TEST REPORT

ESD EVALUATION OF THE 7800, 2100 & CX-24

Subject: "ESD" Evaluation of the 7800 , 2100 & CX-24
Proline Controller

FIGURE 1

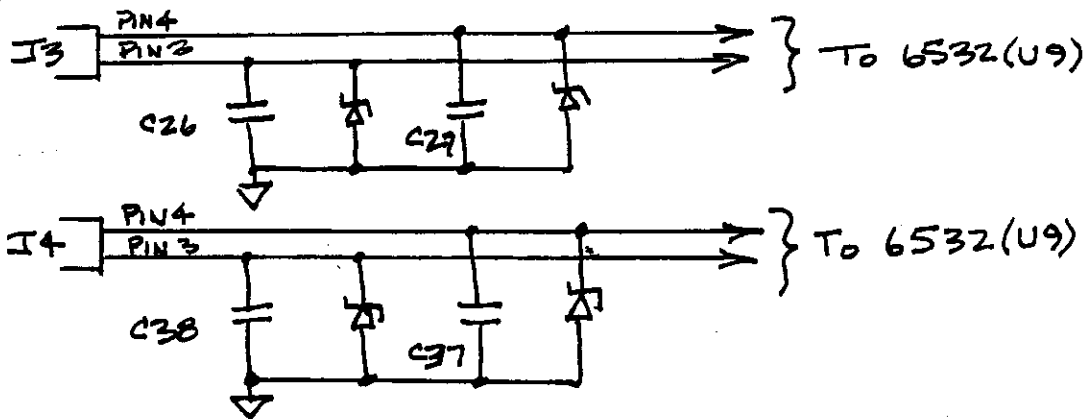
The 7800 console, 6532 IC, fails at an "ESD" level of 25KV applied to port 1 or port 2 with the controllers inserted. An acceptable solution is to add 12 Volt zener diodes, C062081, to Rev. 7.0 P.C.B. as shown in figure 1.

Provide the basic "ESD" protection for the console ports, by adding the zeners as identified in figure 1. (Dan Schwinn of GCC was notified 3/15/84 by FAX, ref. C024673-159, that the additional zeners are required for "ESD" protection.)
